SOLICITATION AMENDMENT MODIFICATION DE L'INVITATION

Title - Sujet New 50 Man Living Units - Ferndale	
Solicitation No. - N° de l'invitation EZ899-131401/A	Amendment No. - N° modif. 004
Client Reference No. - N° de référence du client	Date 2012-11-02
GETS Reference No. - N° de référence de SEAG PW-\$PWY-005-6794	
File No. - N° de dossier PWY-2-35164 (005)	CCC No./N° CCC - FMS No./N° VME
Solicitation Closes - L'invitation prend fin at - à 02:00 PM on - le 2012-11-09	Time Zone Fuseau horaire Pacific Daylight Saving Time PDT
F.O.B. - F.A.B. Plant-Usine: <input type="checkbox"/> Destination: <input checked="" type="checkbox"/> Other-Autre: <input type="checkbox"/>	
Address Enquiries to: - Adresser toutes questions à: Pillay, Sal (PWY)	Buyer Id - Id de l'acheteur pwy005
Telephone No. - N° de téléphone (604) 775-9386 ()	FAX No. - N° de FAX (604) 775-6633
Destination - of Goods, Services, and Construction: Destination - des biens, services et construction: CSC - Ferndale Institution - Mission, BC

The following changes in the tender documents are effective immediately. This addendum will form part of the contract documents.

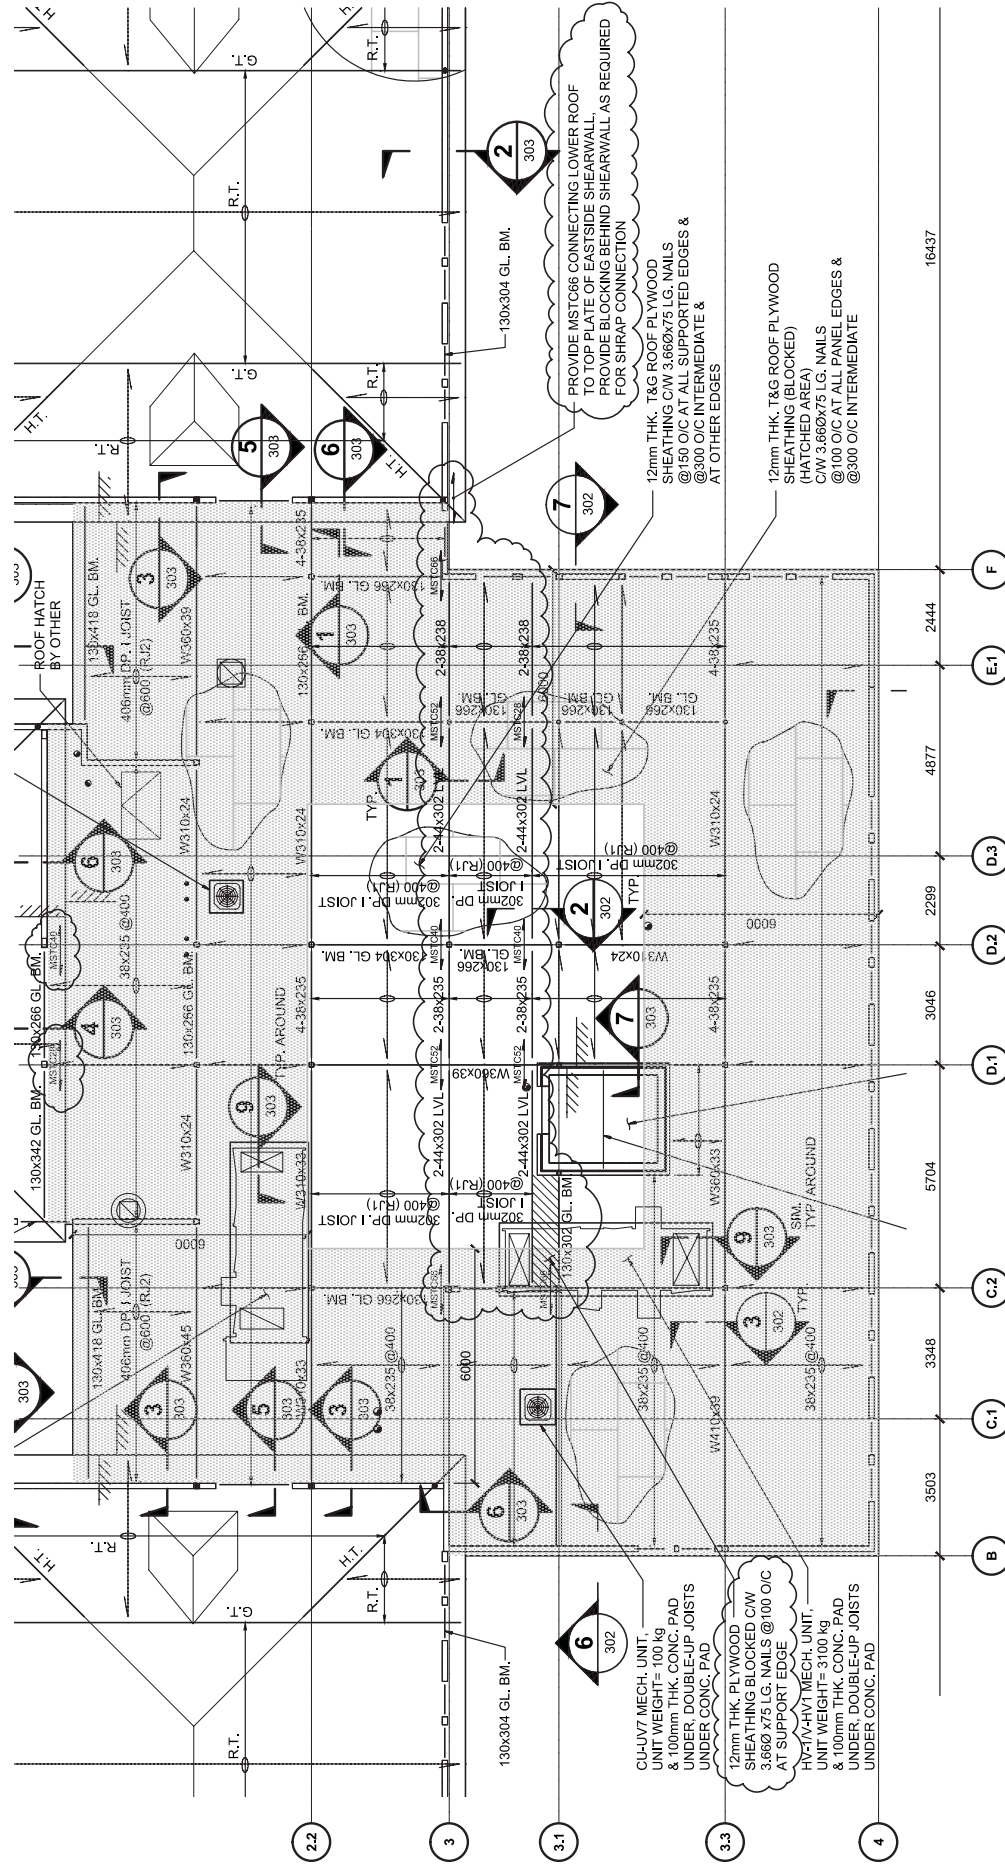
(35) **Revise:** the 450 deep footing under Stair #1 to be 500 deep reinforced with 20M@250 each way top and bottom plus supplementary rebar shown on the plan. Provide hooks at footing edges/ends or extend bars minimum 900mm pass the 500 deep footing.

(36) **Revise:** the thickness for HSS columns for column types C1, C2 & C3 to be 6.4mm from Ground Floor to Roof on Column Schedule.

SHEARWALL SCHEDULE

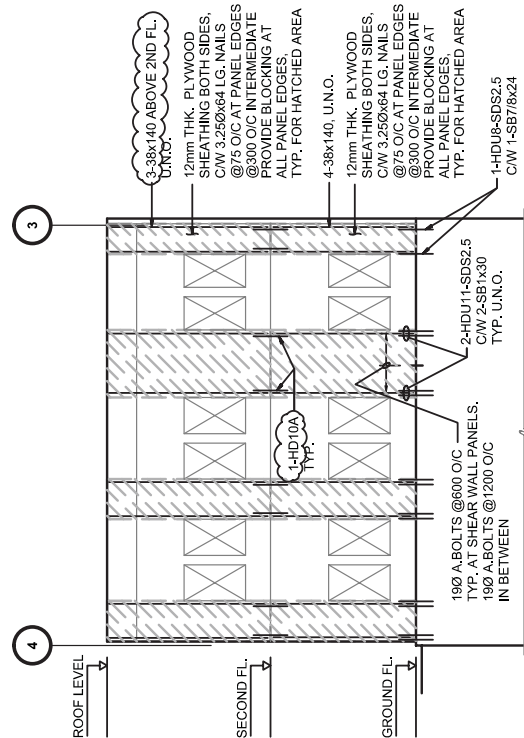
(39) **Revise:** Shear Wall Schedule for wall types SW3/SW5, SW7 & SW8 as per attached addendum sketch AD-S05.

SHEARWALL SW7 & SW8
ELEVATION REVISED
(XREF. DWG. SF-401)

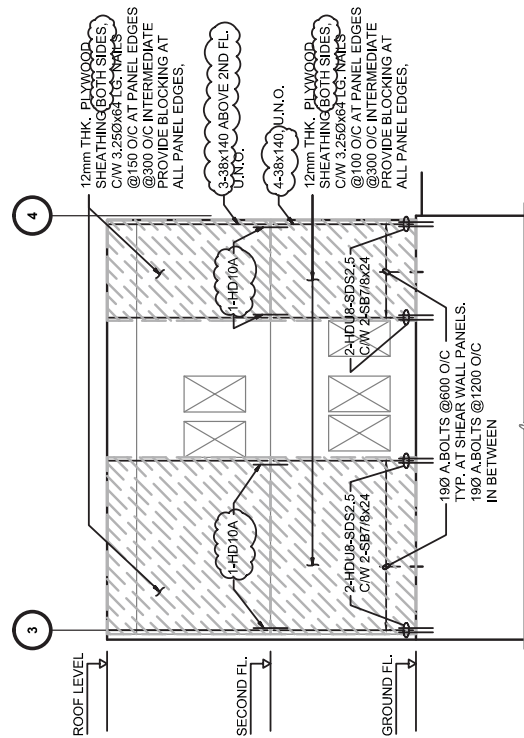
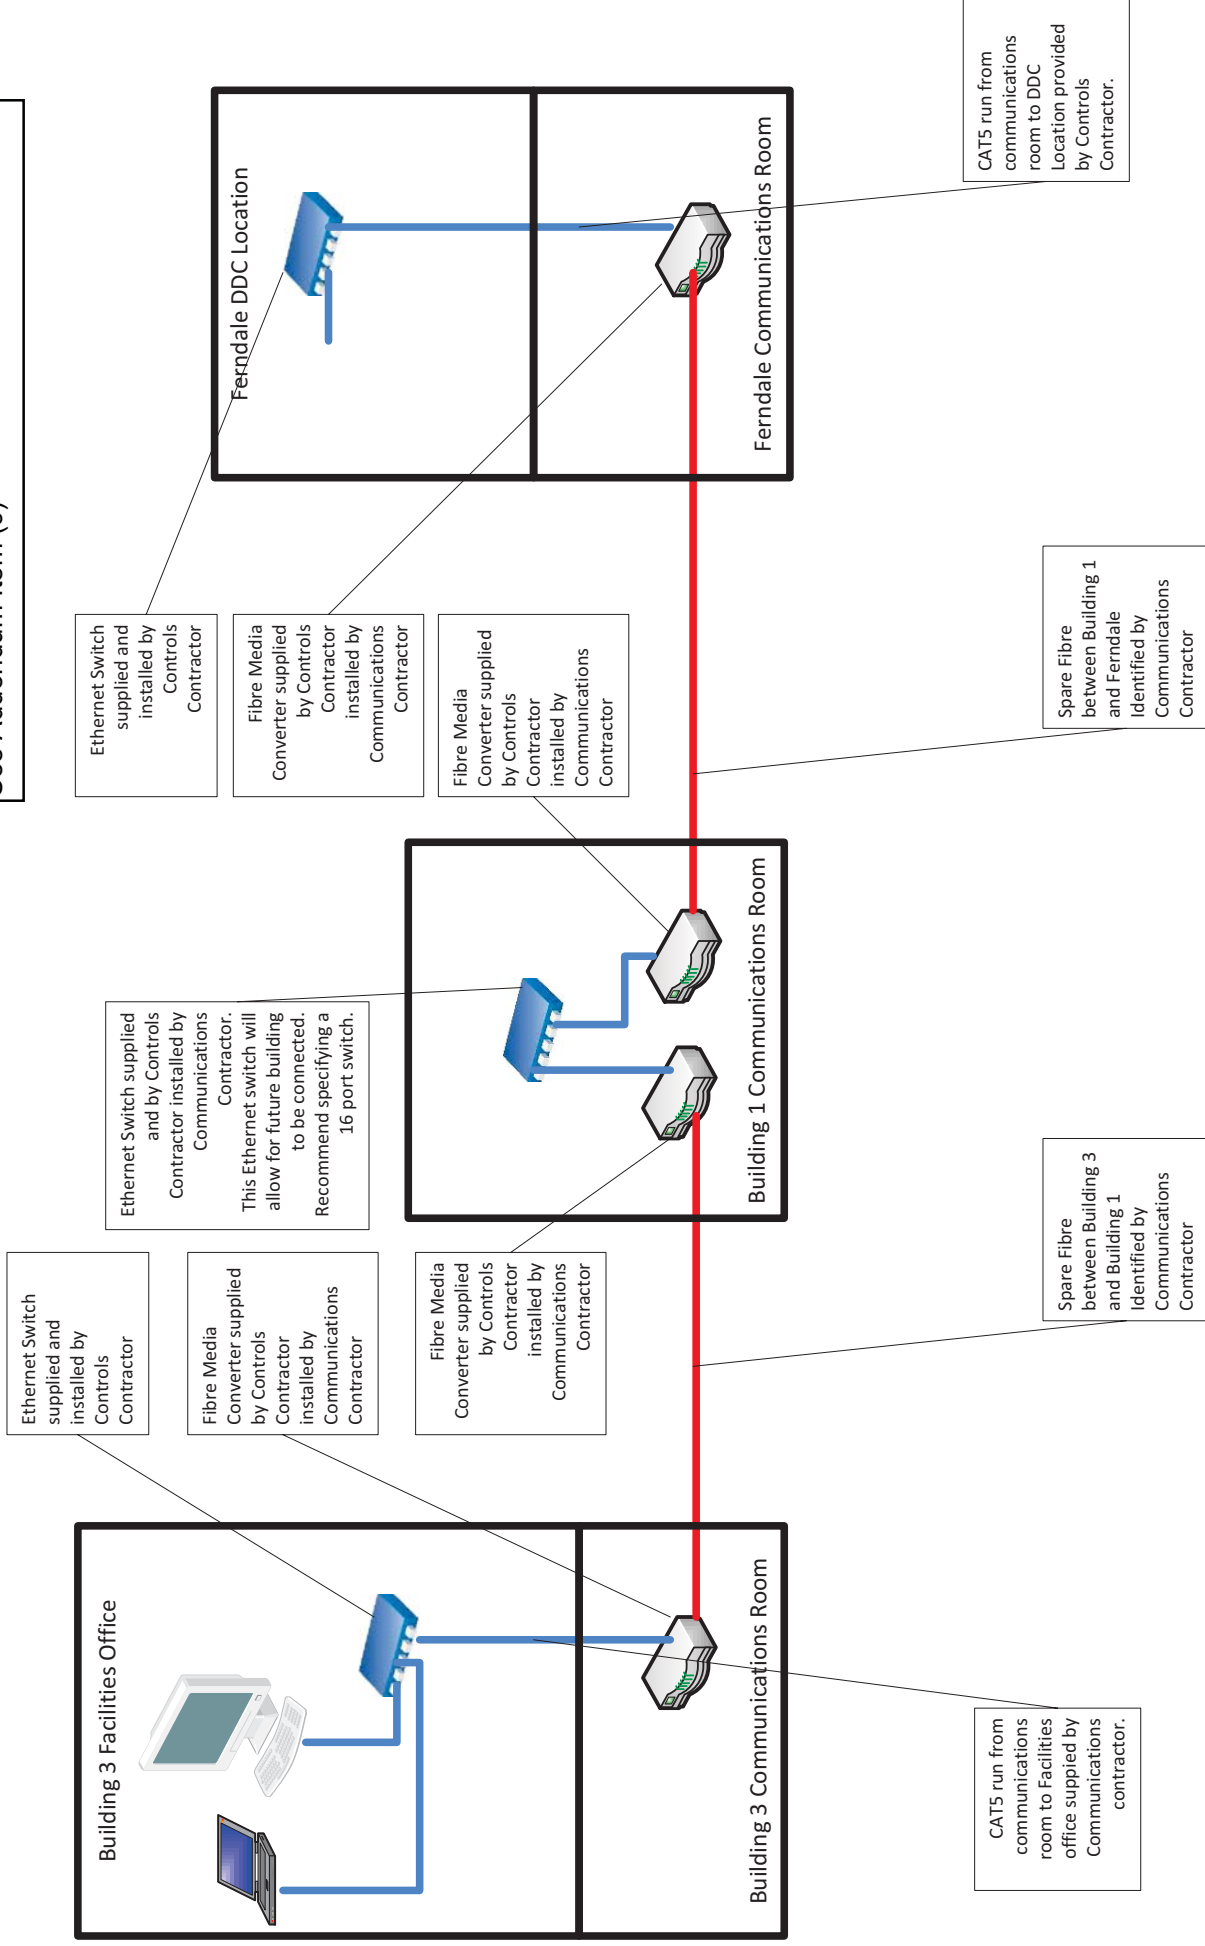
(40) **Revise:** Shear Wall Elevations for wall types SW7 & SW8 as per attached addendum sketch AD-S06.

| .3 | Question: | The Shearwall Schedule on SF401 indicates "12mm PLYWOOD BOTH SIDES " for SW7, but the elevation for SW7 indicates "12mm THK. PLYWOOD SHEATHING ONE SIDE ". Please clarify – one side or both? |
| .8 | Question: | Shearwall Schedule on SF401 shows 3-38x140 studs at each end of the SW8 walls at the second floor level to roof, but the elevation shows 2-38x140 studs. Please clarify. |

Proj. No. R04494.001	Scale: N.T.S.	Date: 12Oct31	Designed: K.B.	Drawing No.: ESK-E004-01
-------------------------	------------------	------------------	-------------------	-----------------------------

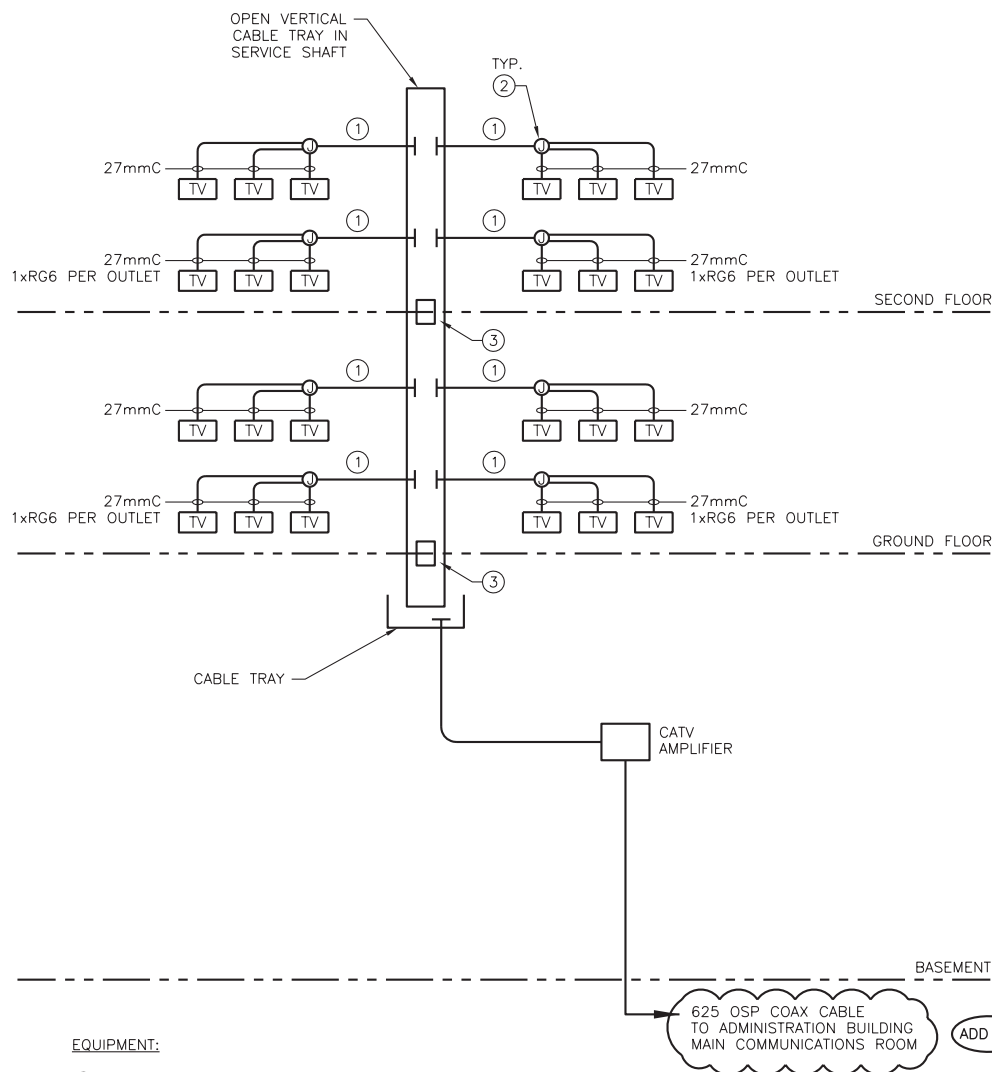
- (46) **Replace:** Detail B with detail shown in ESK-E004-01.
- (47) **Replace:** Detail C with detail shown in ESK-E004-02.
- (48) **Replace:** Detail D with detail shown in ESK-E004-03.
